**REQUEST**

Current Zoning: R-5 (single family residential) & R-22MF (multi-family residential)  
Proposed Zoning: UR-2(CD) (urban residential, conditional)

Approximately 1 acre located near the SE intersection of Parkwood Avenue and Hawthorne Lane in the Plaza Midwood community.

**SUMMARY OF PETITION**

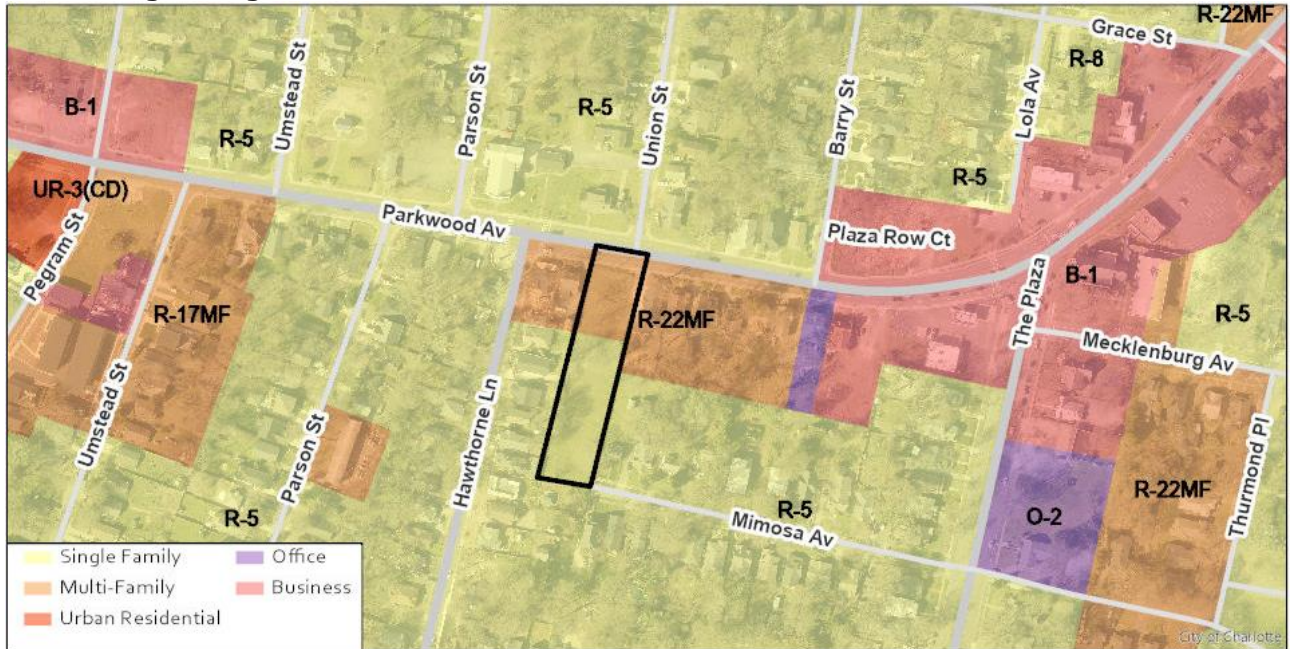
1. ~~Revise the driveway to Mimosa Avenue to meet Charlotte Land Development Standards Manual for two-way circulation since it is a shared driveway.~~ **ADDRESSED**

2. ~~The petitioner should present a design that is more aligned with the future land use of the parcel and reflective of the surrounding residential context that is proximal to the site along Mimosa Avenue and Parkwood Drive. These changes should reflect a reduction in density, height, and overall impervious area of the proposal. The proposed surface parking lot is not supported in any form.~~ **RESCINDED. The petitioner has added pervious pavers to a portion of the surface parking lot. A reduction in height has also been provided.**

3. ~~Coordinate with Charlotte Fire to resolve the required provision of an approved turnaround.~~ **ADDRESSED**

### • **Proposed Request Details**

- **Proposes 29 surface parking spaces and three garage parking spaces – provides pervious pavers for a majority of the parking lot.**
- Commits to a multi-family building height of ~~50~~ 40 feet (**three stories**) and single family attached maximum building height of 35 feet (**2.5 stories**).

- ~~Commits to treating the driveway entrance at Mimosa with masonry columns on either side.~~
- **Restricts vehicular connections to the site from Mimosa Avenue.**
